The Greater Cambridge Design Review Panel

Pre-application re: PPA/22/00056

**Former Waste Water Treatment Facility, Cambridge Road, Hauxton,
Cambridgeshire, CB22 5HT**

Thursday 11 May 2023, Hybrid meeting

Proposed Layout Plan including building heights – extracted from the applicant’s DRP presentation document 11.05.2023

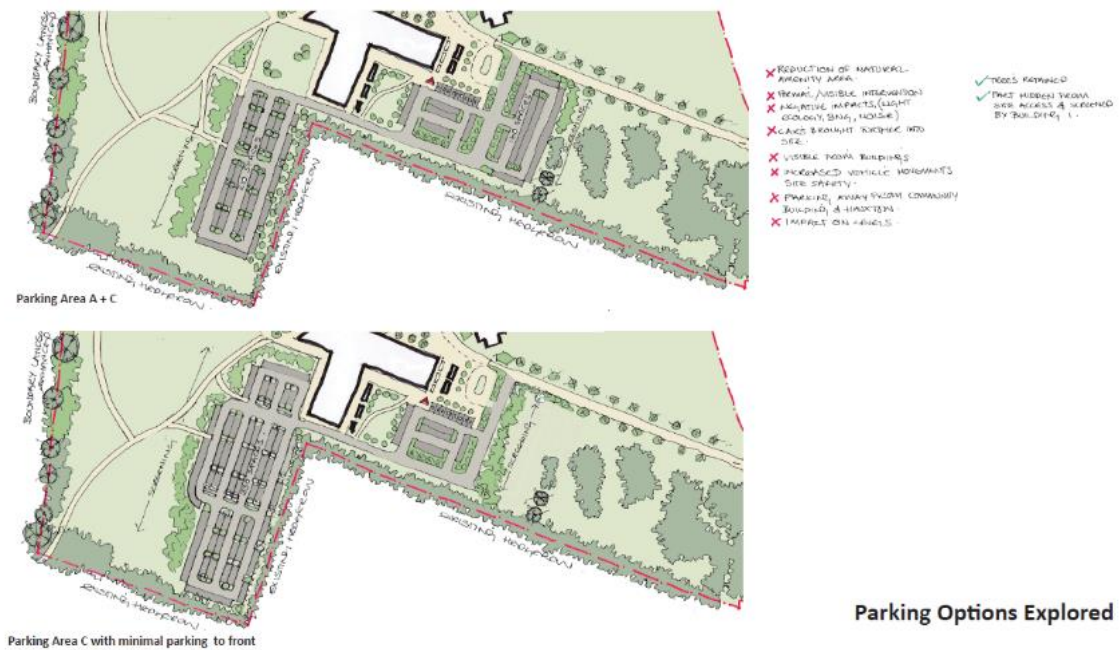
From a masterplanning perspective, the existing sports field is a good starting point but as currently conceived, the masterplan shows a very large car park immediately adjacent and then at the western edge of the sports ground, there is a three-storey building (no. 2, at 4.5m per storey). The Panel is not convinced that as a consequence, an appropriate setting is being created for the village. The absence of an LVIA is an issue in this context, as it comes back to the capacity of site and then the size of car parking area. Without that assessment, it is not possible for the Panel to comment in any detail on masterplanning for footprint or height. By way of comparison and in terms of application parameters, the Panel has been advised by the applicant team that the footprint of the extant outline permission for up to 32 new homes would be less than one third of the proposed R and D buildings (of around 24,155 sqm net (27,870sqm gr.)).

The design team refers extensively to bringing the Green Belt landscape into the scheme, yet the layout is quite hard and the proposed buildings are very close together. Noting that the applicant team describes being at the stage of early design thinking, the Panel appreciates the explanation given of evolution to date. In summary, the first feasibility study was for a very geometric response, followed by looking at how it could be fragmented. Various further iterations then included a technical evaluation of footprints after early pre-apps, and how the buildings could be subdivided, adapted and future proofed while staying within the previously developed land zone as much as possible (including the area of existing bunds). Retaining the same footprint from pre-app 1, the design team has tested/ revised spaces between the buildings, and their sub-division and internal layouts for a different arrangement of suites, served by series of cores. A series of six 24m-wide buildings has resulted (the optimum dimension for offices/ dry labs/ wet labs), being described by the design team as embedded in the landscape. Building no.1 (the southernmost block, at two and three storeys) is 'T'-shaped to respond to an historic field boundary and intended to create a 'wonderful' arrival space. Blocks nos. 2 and 3 are parallel, three-storey north east/ south west-aligned buildings to the north east. According to the design team, the scheme then 'relaxes, with three 'structures' i.e. buildings (blocks nos. 5 and 6 being two-storey, and the northernmost block no. 4 is two- and three-storey), with 'fingers of green space between, to soften them'.

In terms of the buildings themselves, the Panel agrees that they can make 'a real contribution'. However, while understanding the 'barn' concept, the Panel's view is that this is out-of-scale with Hauxton. The design team refers to building nos. 1, 2 and 3 in terms of being closest to the site entrance and having a warm palette of materials, shutters/ screens changing the nature of their facades and brown zinc roof forms that would be very expressive. But a 'cliff edge' of buildings in terms of their predominantly three-storey bulk and massing is created on coming into the site. Instead, the Panel suggests that scale could be built up, utilising green roofs and
